SEWAGE WORKS, ROYSTON
LAND TO THE NORTH OF A505 ROYSTON BYPASS ROAD
PROPOSED IMPROVEMENTS TO DIRECT ACCESS

**REPORT FOR STAGE 1
OF SAFETY AUDIT
(Safety Audit Ref: DC5 / 536 / 2012)**

SWD/METS CODE: 1046346/007/001

Report Dated: June 2012

FIGURE 2: SITE LOCATION PLAN

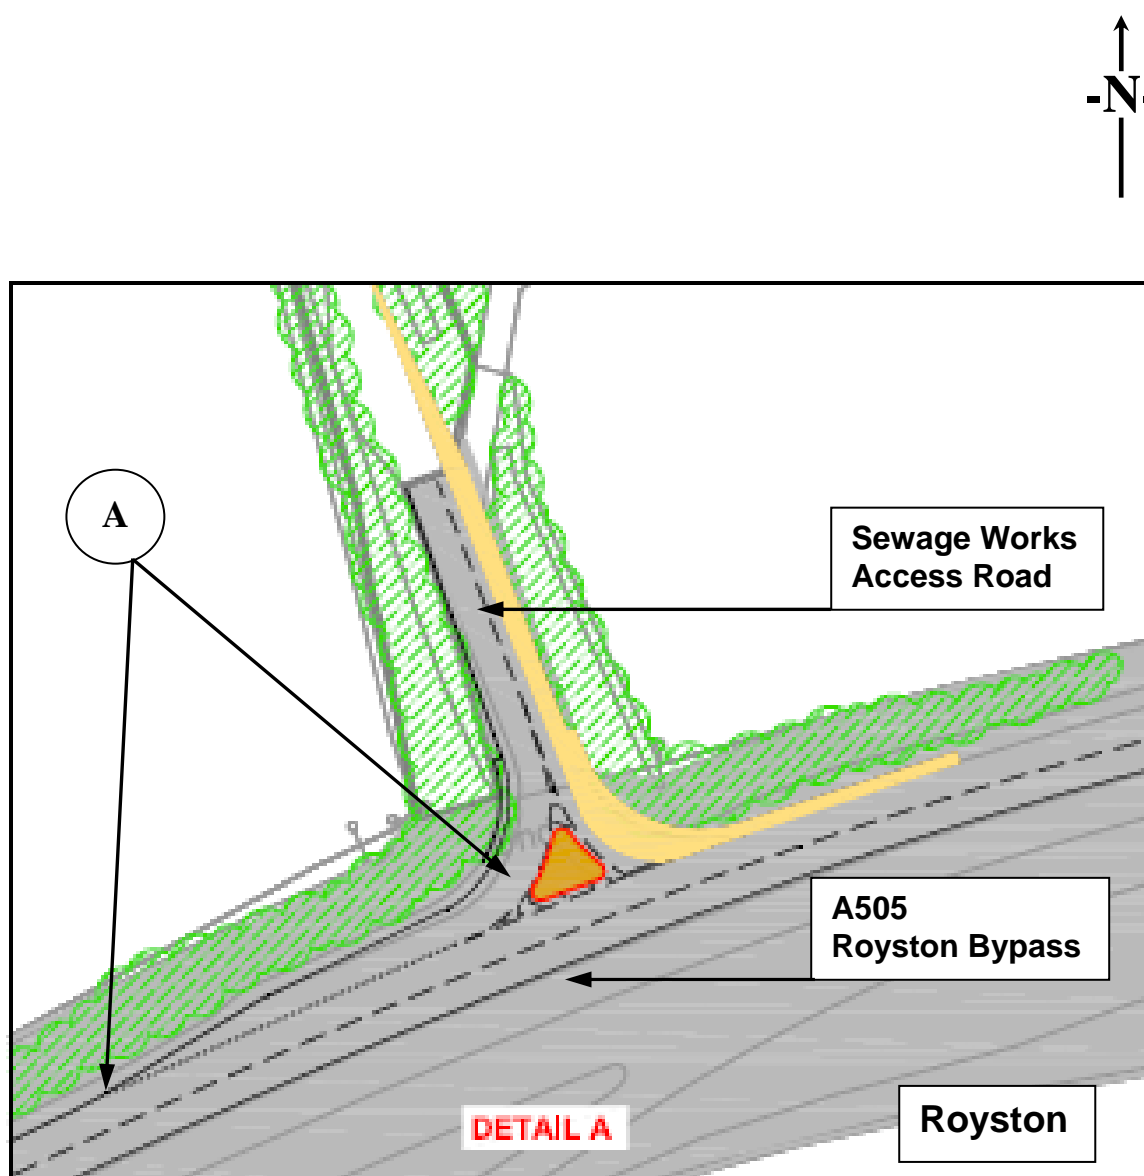
Location A – Access Road J/w Royston Bypass Road

Summary: The existing deceleration lane for the Sewage Works access road junction with A505 Royston Bypass is too short, which results in left turning vehicles decelerating in Lane 1 of the dual carriageway.

- The existing auxiliary lane for those vehicles leaving the A505 to join the site access road is too short to meet current design standards. There is likely to be a propensity for larger vehicles attracted to the site to slow down in the eastbound Lane 1 of the dual carriageway; to negotiate the short deceleration lane for the Sewage Works junction.

- There is evidence that the near side kerb line around the western side of the access road bell mouth is overrun by larger vehicles – there are no proposals shown on the drawing to improve the exit width into the side road.

- The bell mouth on the eastern side of the access road junction is to be widened, to better accommodate the left turning movements of larger vehicles leaving the access road – the existing bell mouth kerbline and the verge behind it are currently being heavily overrun. The removal of the small trees and bushes at the back of the verge to accommodate the junction improvements would remove the current edge restraint, should an errant vehicle leave the dual carriageway at this location. (There is a significant change in levels down the embankment behind the verge).

A lack of appropriate deceleration lane length for the side road junction could leave through vehicles more vulnerable to conflict with a slow moving left turning vehicle in Lane 1 of the A505 eastbound carriageway on this high-speed road, with the attendant risk of a collision occurring as a result.

The auxiliary lane for vehicles decelerating for the side road junction should be at least 80m long, so that those vehicles turning left into the Sewage Works can slow down off the mainline of the eastbound Lane 1 of the dual carriageway.

The radius of the western bell mouth and the width of the traffic lane into the access road should be increased to better accommodate the turning movements and swept paths of those larger vehicles attracted to the development site.

The provision of a longer auxiliary deceleration lane would require removal of the vegetation behind the verge on this northern side of the A505. This would remove the existing edge restraint preventing an incursion by an errant vehicle into the land behind the verge down the embankment. The alterations to the auxiliary lane should also incorporate the provision of a suitable length of safety fencing in the verge alongside the auxiliary lane, to provide a suitable road edge restraint. Similarly, a suitable length of safety fencing should be provided in the verge behind the proposed alterations to the access road and the eastern side of the bell mouth of the Sewage Works junction.

DRAWING NUMBER
E521/001

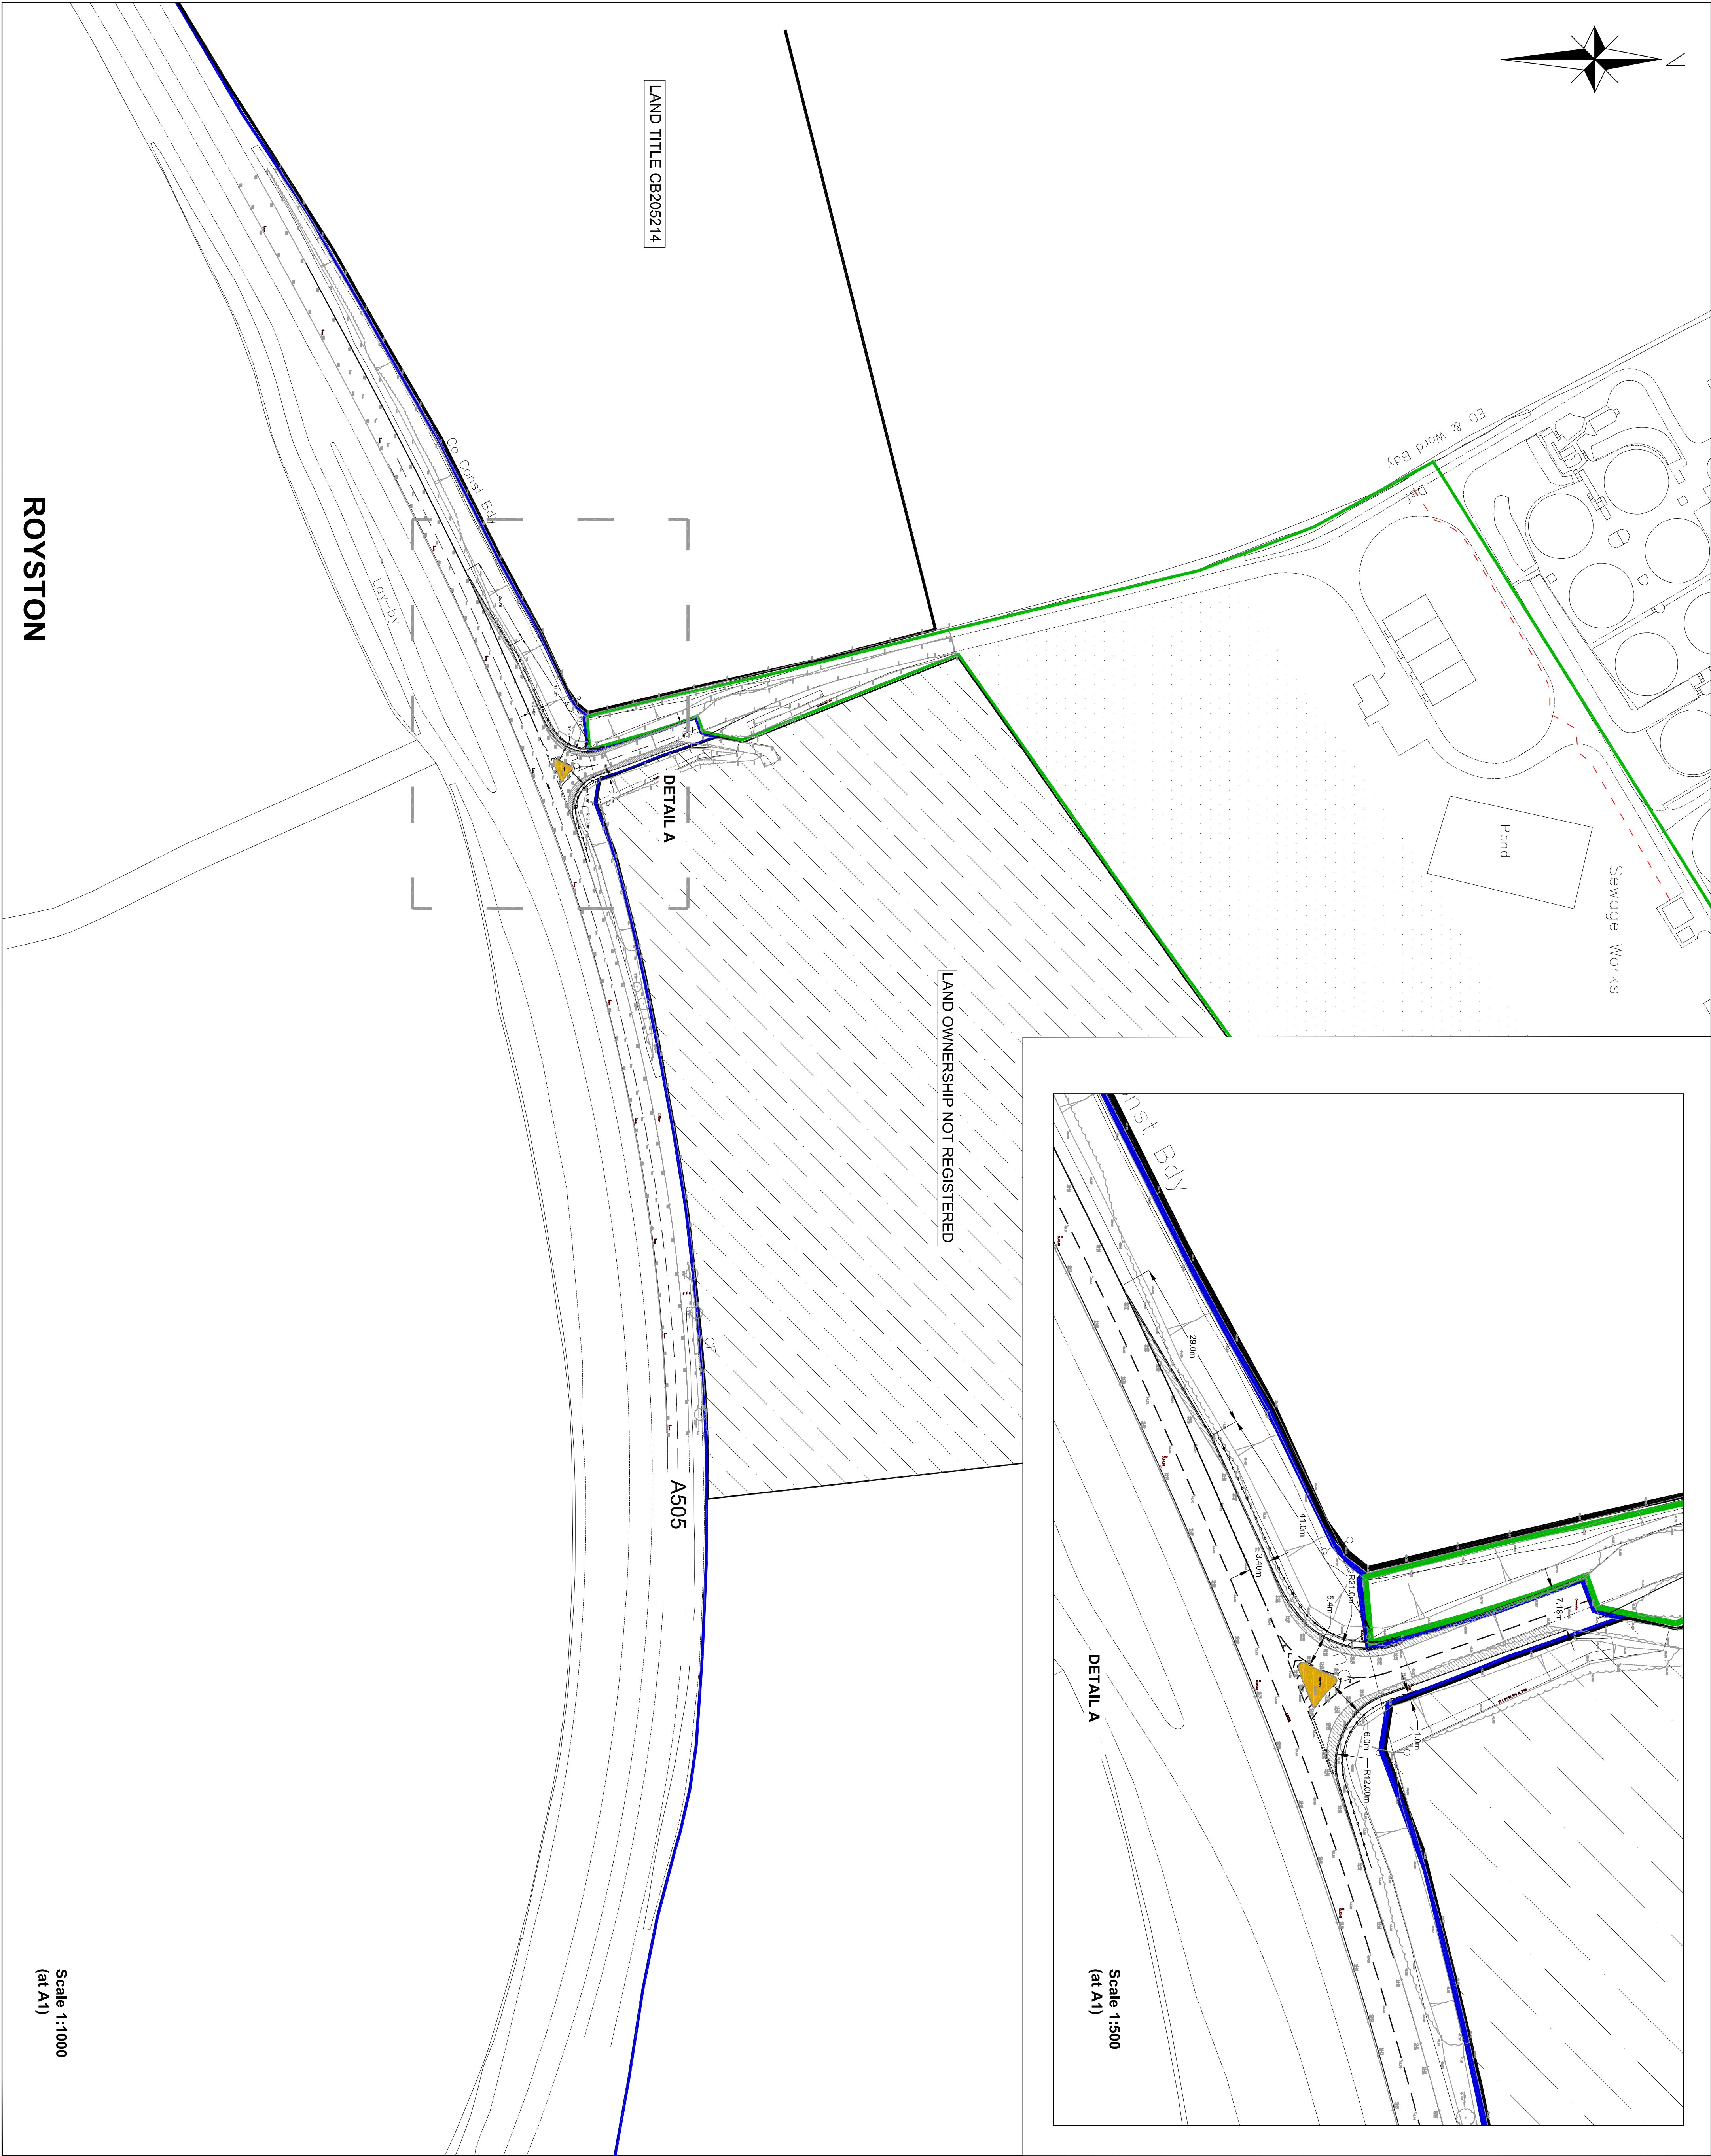
(Drg No: E521/001 Rev A)

Summary: *A lack of suitable guidance for those vehicles attracted to the Waste Water Treatment Works site could lead to hesitation by some drivers not familiar with the site location.*

The Highway Authority may wish to see that suitable direction signs are provided, to direct eastbound and westbound vehicles on the A505 towards the left in/left out junction. In particular, the use of a direction sign on the westbound approach to the site along the A505 dual carriageway would be beneficial. A sign similar to Diag 2010.1 (TSRGD) could be used; to show that vehicles attracted to the Waste Water Treatment Works should U-turn at the subsequent roundabout junction.
